Product Change Notification

Product Change Notification Number: DV122010 Date: 01-12-2010

Title: Design change of enclosed jackscrews for the backshell series DVPK and DVZK

New Jackscrews for DVPK and DVZK

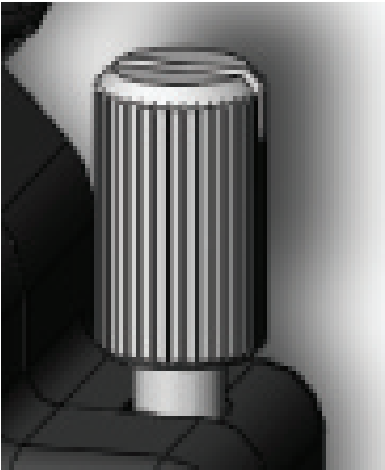
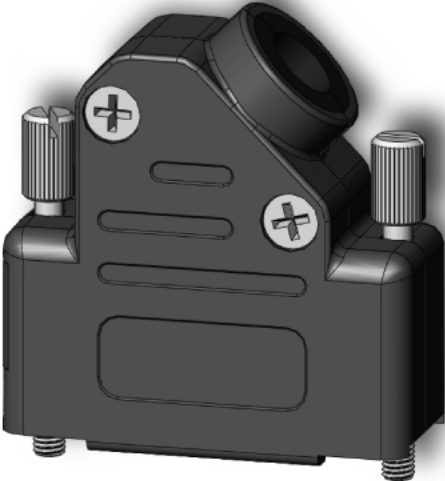
This PCN is related to further improvements of DVPK and DVZK series with the design change of the jackscrews enclosed the backshells. This change is related to creation of more similarity between angled cable outlet backshells and straight cable outlet backshells, where the design of jackscrews with coloured plastic knobs on metallic screws already exists. Further more are the Ni-plated surface of the jackscrews replaced by Zi-plating to eliminate some of the allergenic subjects. Previous version with solid metal jackscrews will be available after 01-04-2011 upon request.
